TO: DCHC MPO TC  
 FROM : Filmon Fishastion, MPO Staff  
 SUBJECT: FY2024-2033 TIP Amendment #4 Public Comments

RE: Comments on Amendment #4 to the FY2024-2033  
Transportation Improvement Program (TIP)

Thank you for the opportunity to offer the attached comments on DCHC MPO's Amendment #4 to the FY2024-2033 Transportation Improvement Program (TIP). These comments are for project HE-0007D to add turn lanes and a traffic signal at the intersection of Old Oxford Road and Snow Hill Road in Durham County.

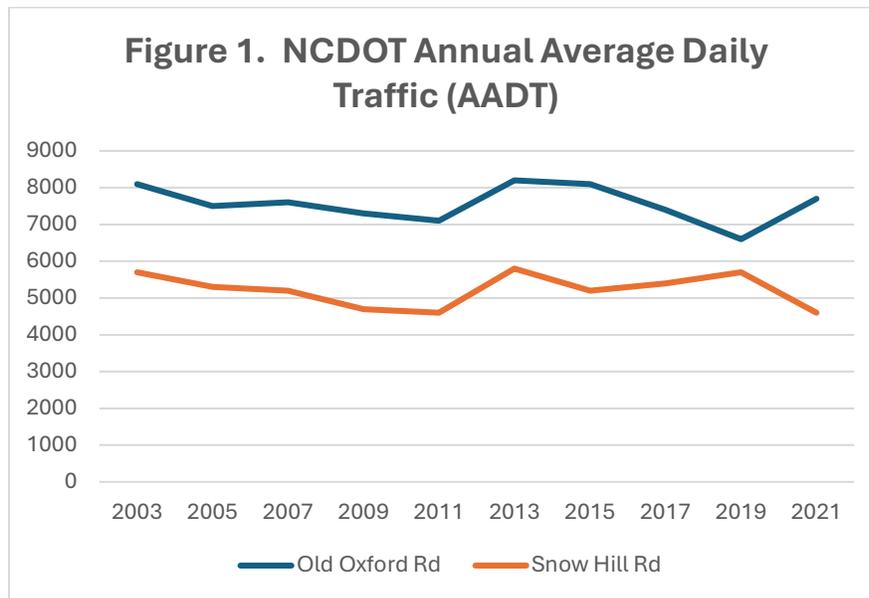
Current traffic volumes at the intersection are about 8000 AADT on Old Oxford and 6000 AADT on Snow Hill Rd (see figure 1). Based on NCDOT SaFID charts, the safest feasible intersection at current traffic volumes is an all-way stop. If traffic volumes increase a bit, the safest feasible intersection is a single lane roundabout.
